ARCHITECTURAL REVIEW COMMISSION AGENDA REPORT

SUBJECT: REVIEW OF BUILDING AND SITE IMPROVEMENTS, INCLUDING AN APPROXIMATE 4,300 SQUARE FOOT ADDITION; TENANT IMPROVEMENTS; FAÇADE REFRESH; SIGN PROGRAM; AND ACCESS, PARKING, AND LANDSCAPING UPGRADES WITH A FENCING REQUEST IN THE OPEN SPACE EASEMENT.

PROJECT ADDRESS: 3450 Broad Street **FILE NUMBER:** ARCH-0672-2024

Figure 6 – Proposed Sign Program

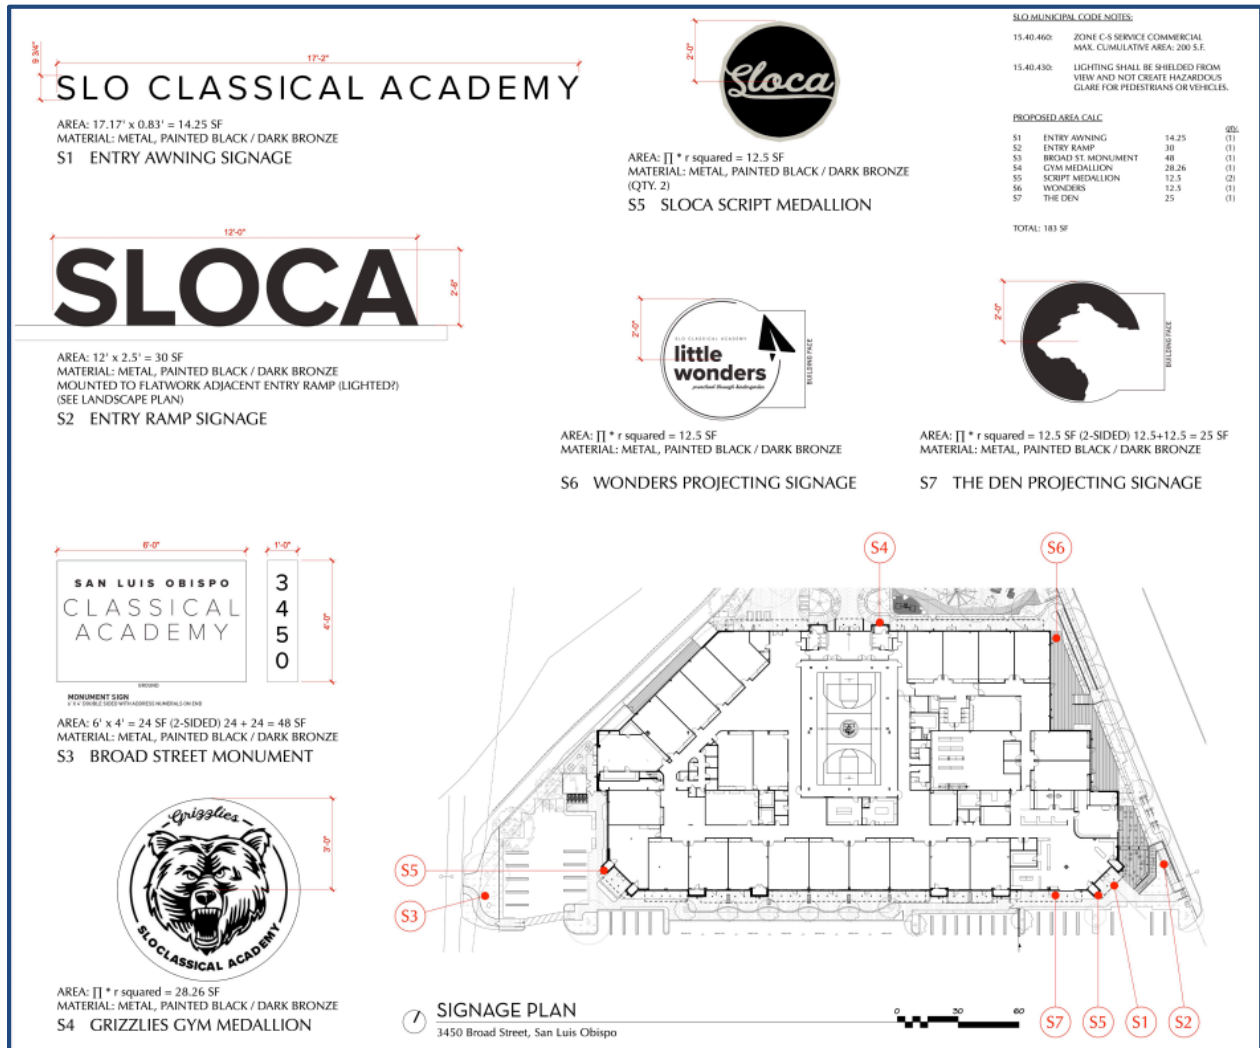
As proposed, the sign program includes a variety of signs throughout the project building and site that are primarily oriented at the street frontages to provide visibility (i.e., awning, monument, and wall signs to indicate SLOCA as the tenant) and at select building entries to indicate changes in the use of different rooms and areas (i.e., wall and projecting signs to indicate the gym, little wonders, and den).

The ARC should review and determine whether the sign program has been designed with consideration to the number of signs (e.g., does the sign program include an adequate number of signs without resulting in clutter?), sign placement (e.g., do the signs provide sufficient visibility and information while remaining well integrated with the project building and throughout the site?), sign scale in relation to building scale, and readability (e.g., are the signs appropriately sized in order to provide information without being too large?). In addition, the ARC should consider whether the colors, placement, and materials of all signs are compatible with the architecture and facade details of the structure.
